# CONSTRUCTION PLANS FOR HILLSIDE AT LORSON RANCH FILING NO. 1 STREET & STORM SEWER CONSTRUCTION PLANS

**HILLSIDE AT LORSON RANCH FILING NO. 1  
STREET & STORM SEWER  
CONSTRUCTION PLANS**

DATE:  
DEC 1, 2022  
PROJECT NO.  
100.065  
SHEET NUMBER  
**C1.1**  
TOTAL SHEETS: 47

**TYPICAL SECTION 50' R.O.W.  
RESIDENTIAL URBAN LOCAL**  
NOT TO SCALE

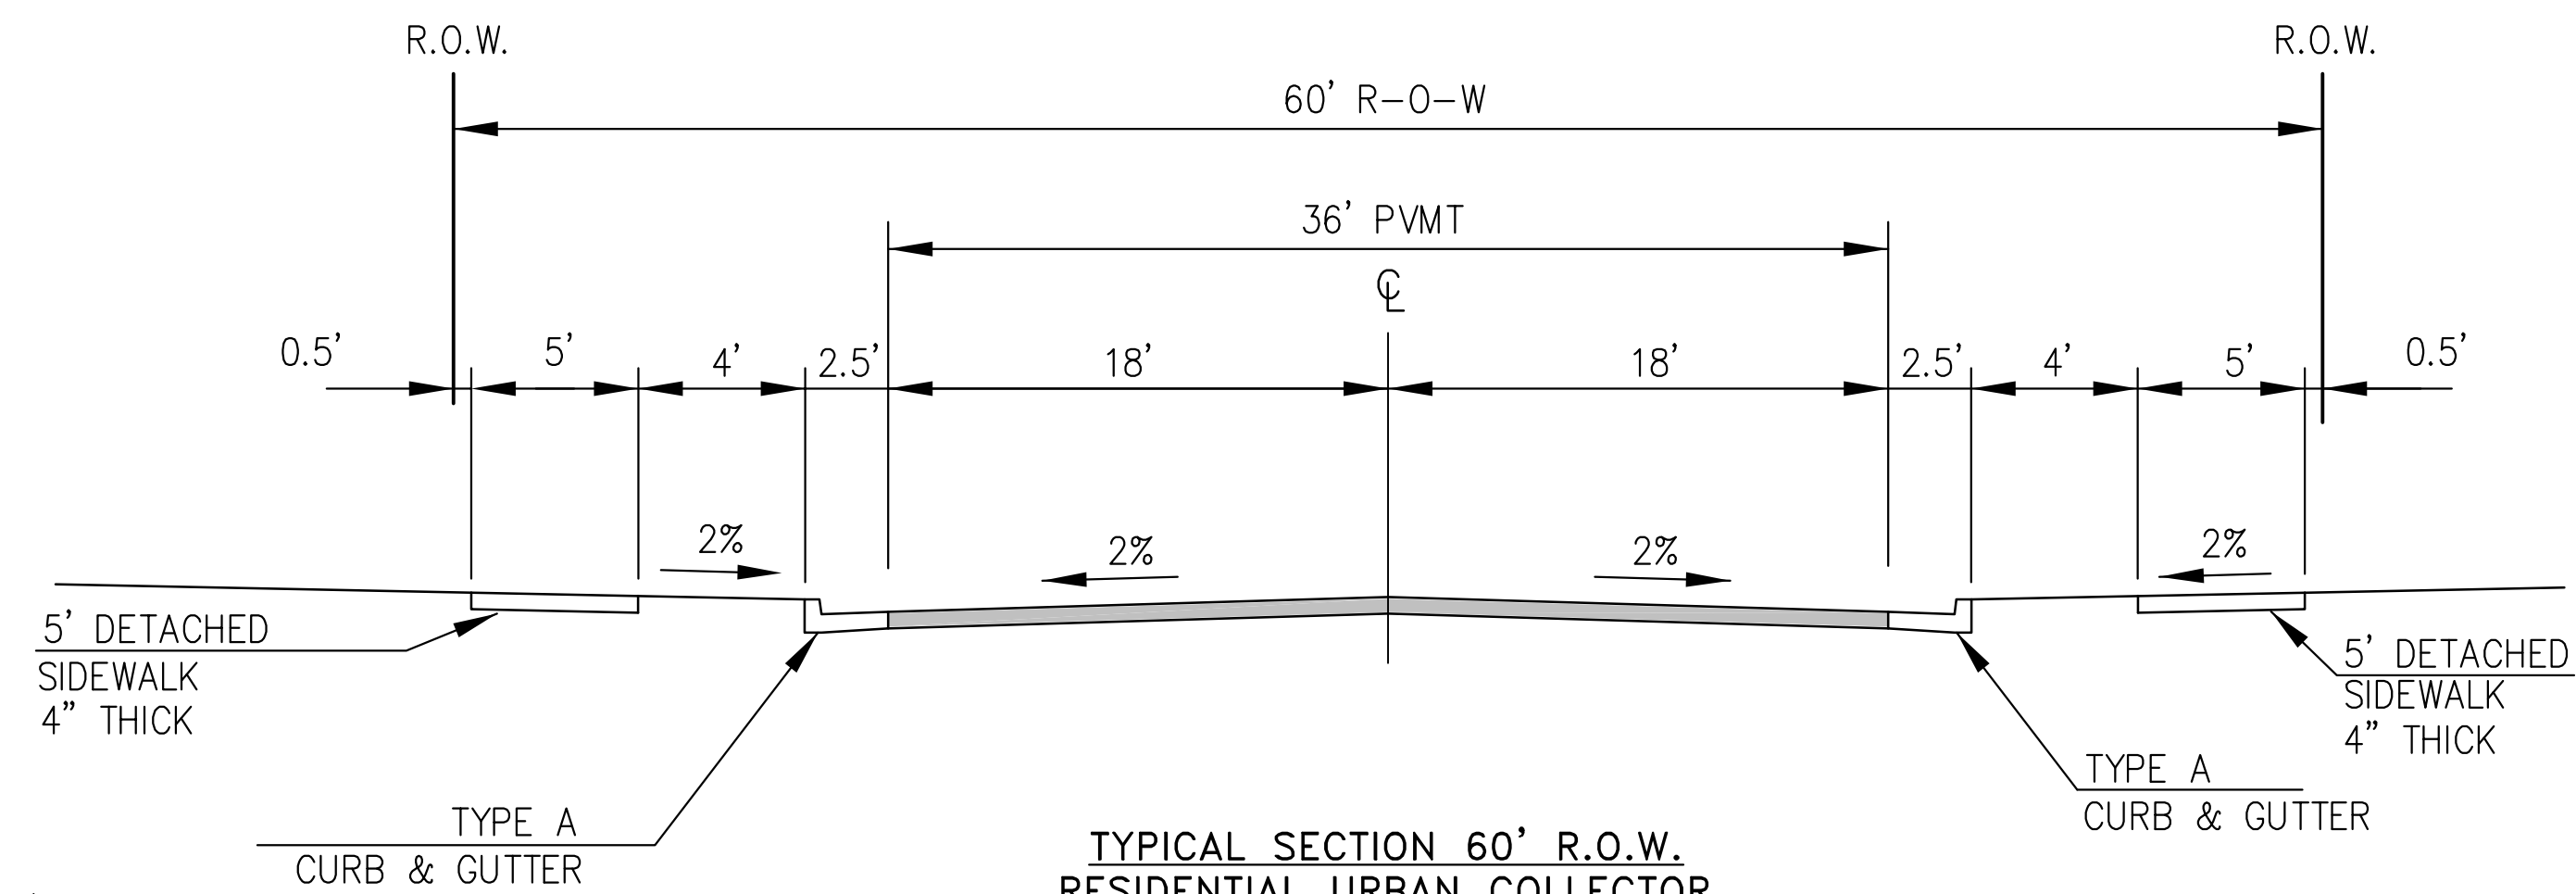
Delete  
Sidewalk along these roads may be 4" except at driveways

SHEET NUMBER  
 C5.1

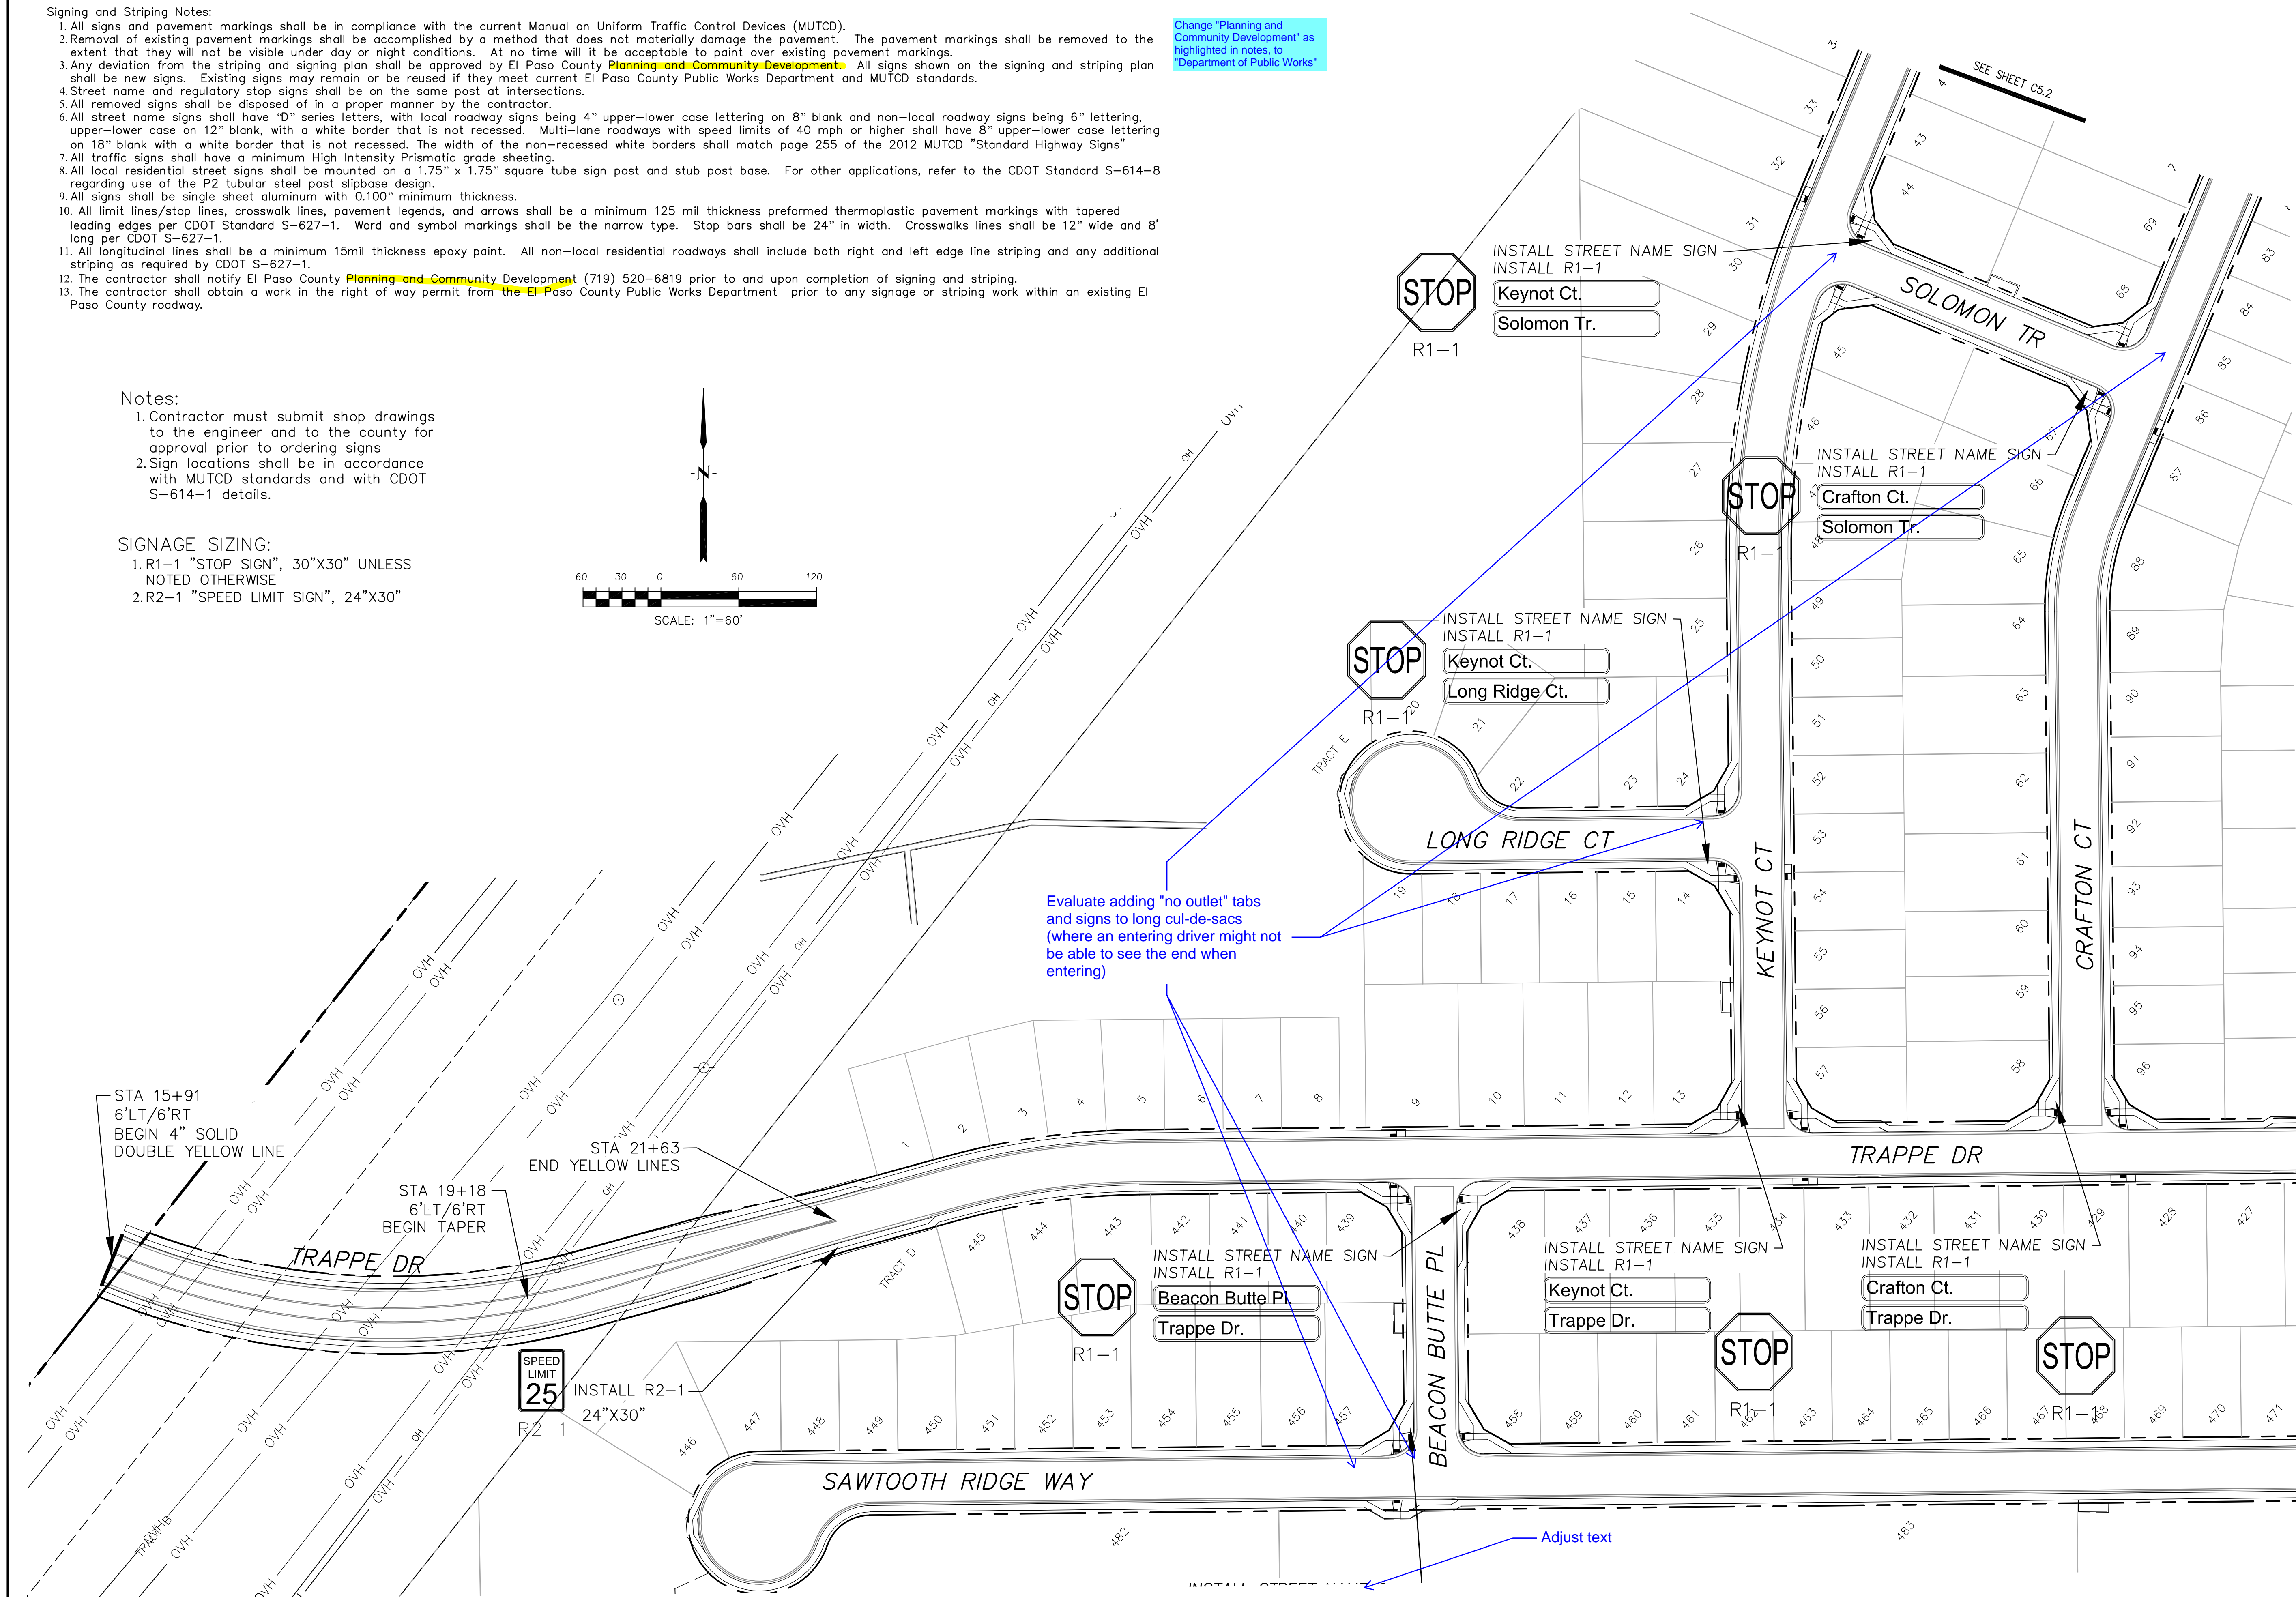
Change "Planning and Community Development" as highlighted in notes, to "Department of Public Works"

SHEET NUMBER  
 C6.4

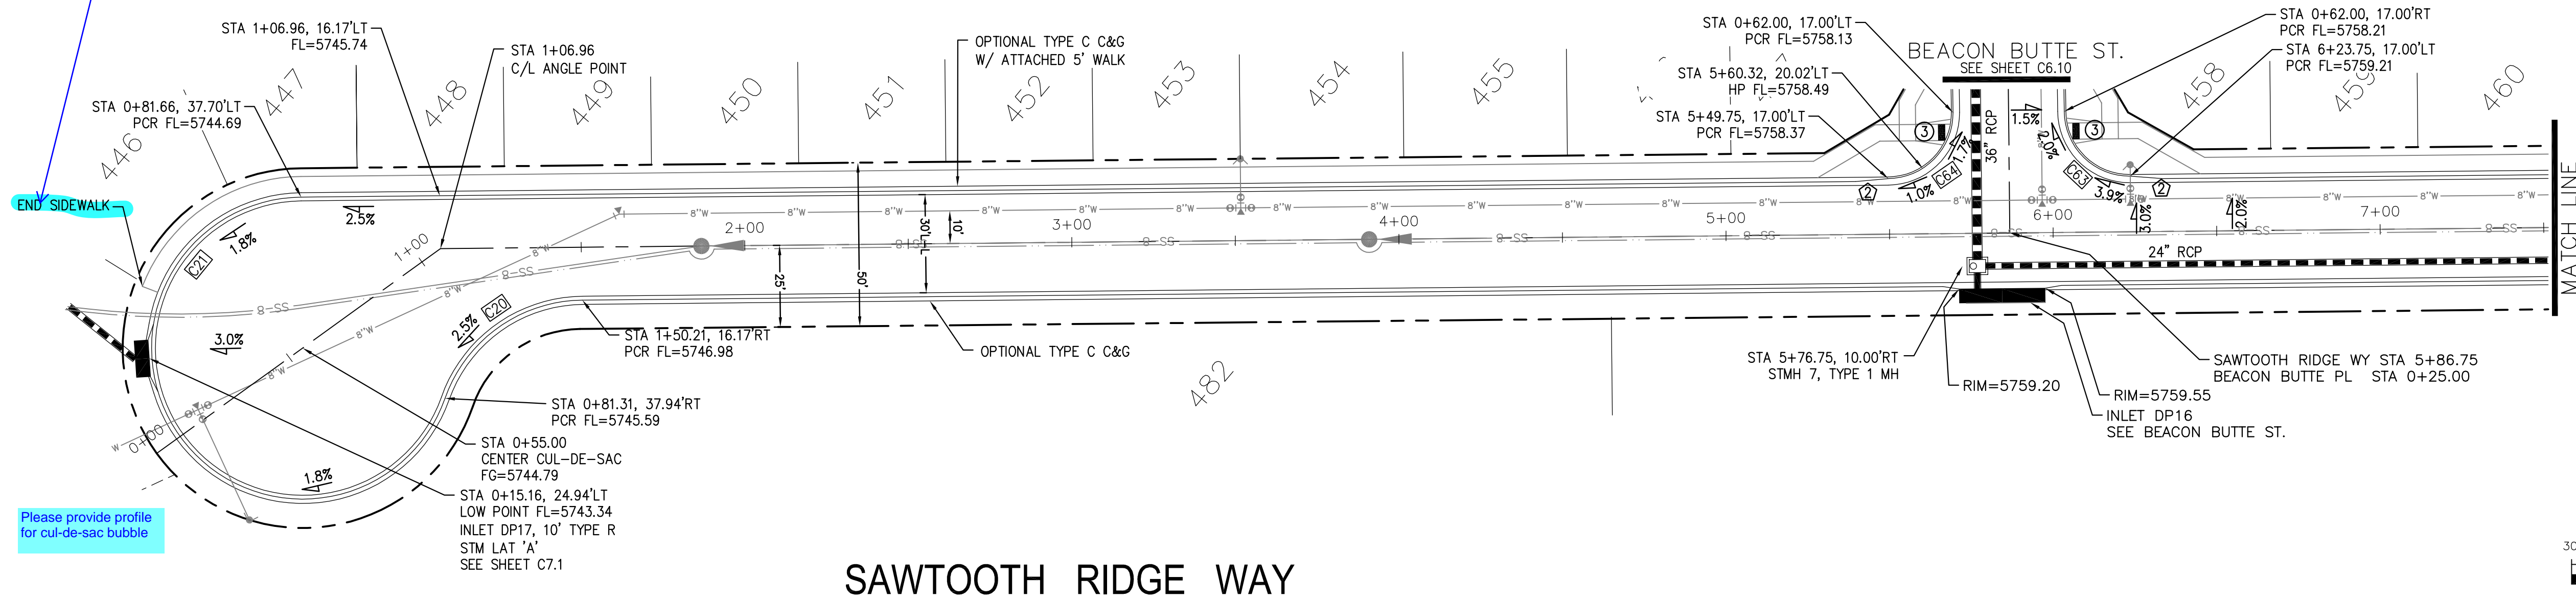
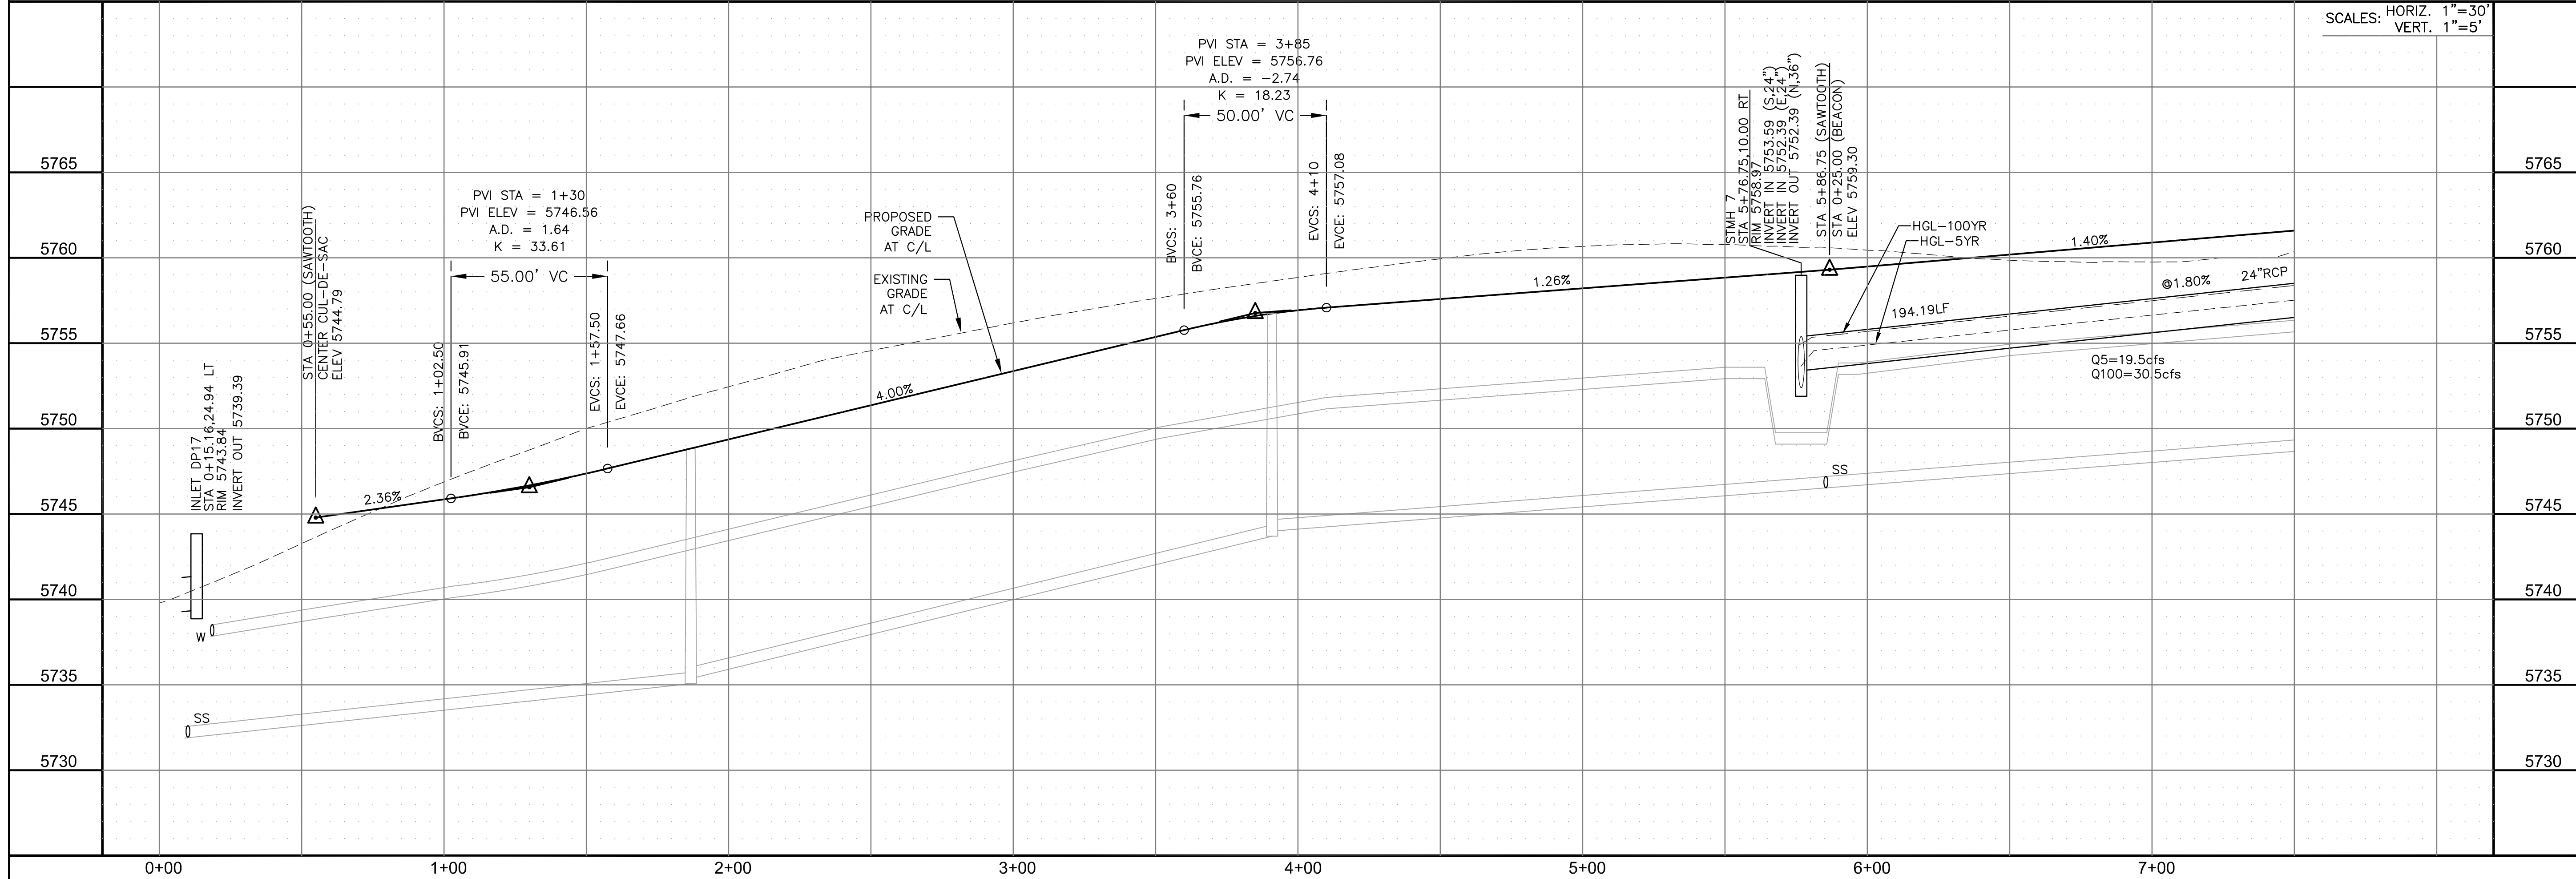
Deviation was not approved

Please provide profile for cul-de-sac bubble
